Wilson Hill Solar is a 5 MW ac generating facility occupying 19.19 acres of a 99.52 acre parcel at 469 Wilson Hill Road, owned by Larry Bugbee. The project has been studied and approved by National Grid for interconnection, and the first payment has been made.

- **Nov '23** Received comments from the board:
 - o SEQR coordinated review notice started on 10/15 to be complete by 11/15
 - o Planting buffer requested

Addressing Comments

IX

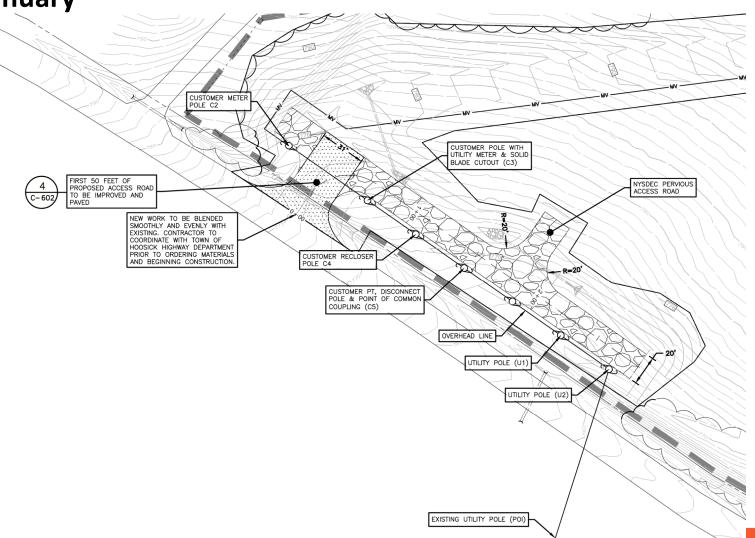
Detailed drawings of the power interconnection plans including visual representations of the above ground planned infrastructure on the site (wires, poles, transformers, etc). Plans were provided in December, 2023, visual analysis has been included with this submission.

MEDIUM DUTY PAVEMENT SECTION

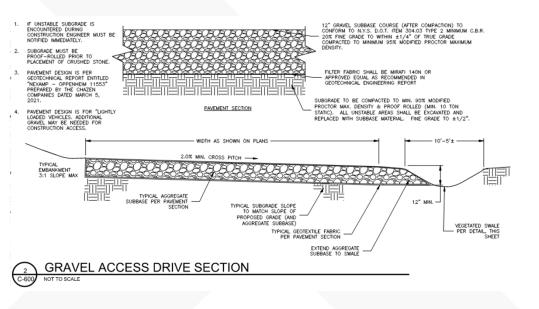
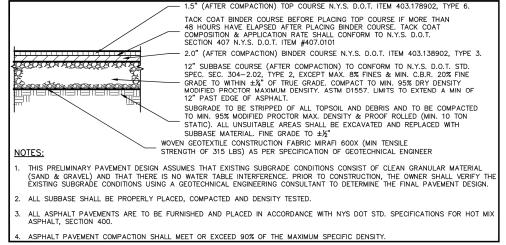
• An engineered plan for the road to include type and depth of gravel for 15 ft width road with fabric at base and finished with vibratory roller: Included in plan submission from December, 2023; portions of the proposed access road will be paved as indicated on the site plans.

Trees

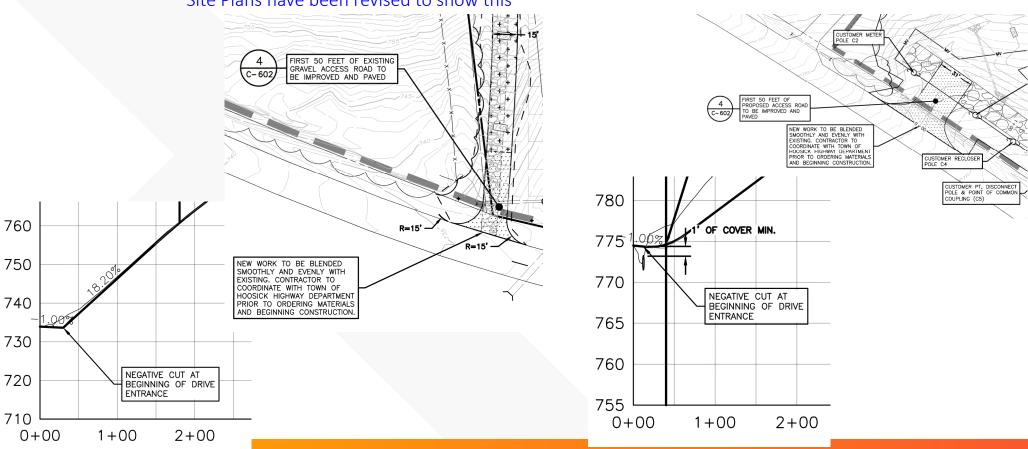
Plans for expanding the visual buffer on 3 sides of project to include a minimum of double row of 7ft evergreen trees along with other species and a minimum depth of six feet. The revised plans incorporate the requested landscaping buffer (highlighted in green for reference).

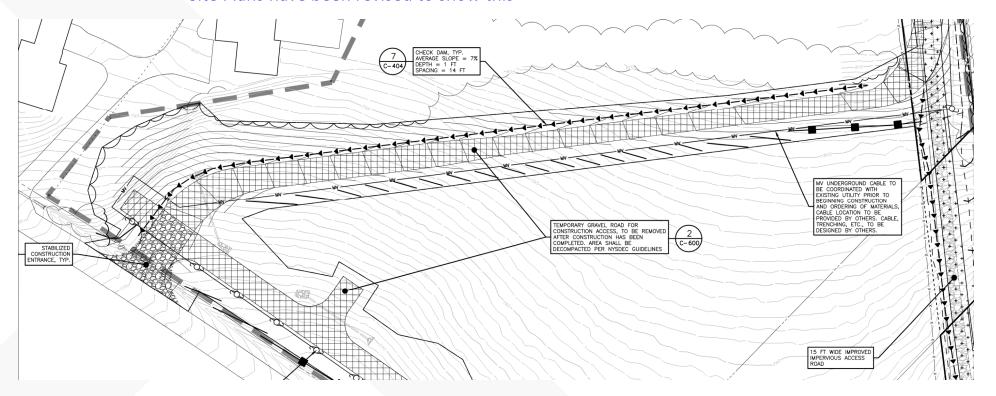
- Road plan to include negative cut as discussed with Town Highway Department
- Road plan to widen and maintain the existing cell tower access road

• Road plan to insure proper water runoff control on temporary road. Site Plans have been revised to show this

Site Plans have been revised to show this

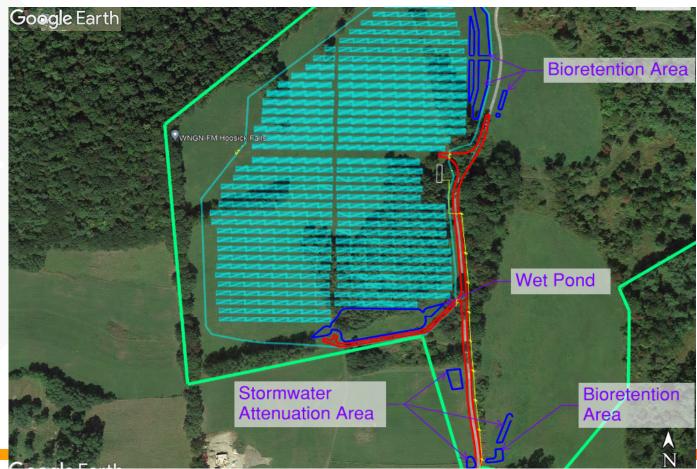
Jan '24 • Robust stormwater runoff plan reflective of all site plan revisions per LaBerge Group and Town Comments - Plans show a conservative stormwater management plan.

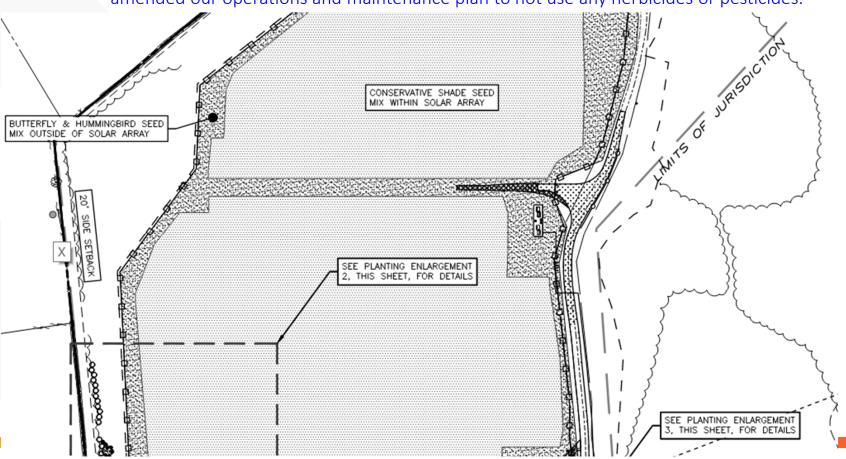
• Plans for seeding with pollinating grasses and vegetation management Plans include provisions for a pollinator mix. Additionally, after meeting with adjacent landowner last month, we have amended our operations and maintenance plan to not use any herbicides or pesticides.

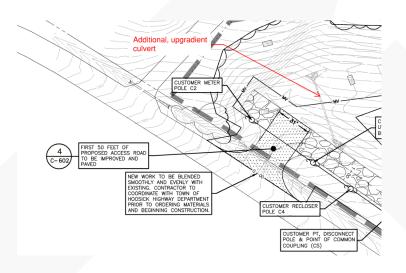
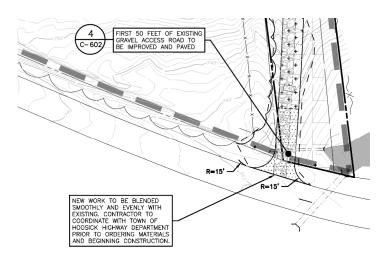
- Vegetation Management Plan: The Operations and Maintenance plan has been revised to include language regarding ongoing maintenance of vegetation.
- Road plan to include paving the first 50 feet of the existing access road and proposed stub road:
 The plans have been revised to reflect this request
- Inclusion of additional culvert under the stub road An additional culvert has been added as requested
- Evaluation of upgradient need for additional culverts Stormwater modelling indicates the additional upgradient culverts will not be required; the stormwater management areas to the north of the access road will divert stormwater away from the access road and reduce flows.

Viewshed Analysis

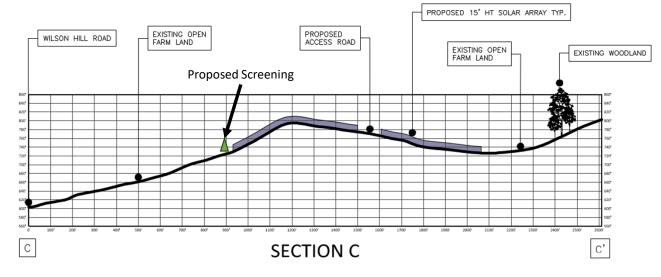
From the visual impact study, only one section, Section C ("receptor 3" in comments) was shown to have potential visual impact. While this section does show potential visibility, it is in fact very limited. The section cuts through a ~100ft break in the existing mature foliage that otherwise obscures the array along Wilson Hill Road.
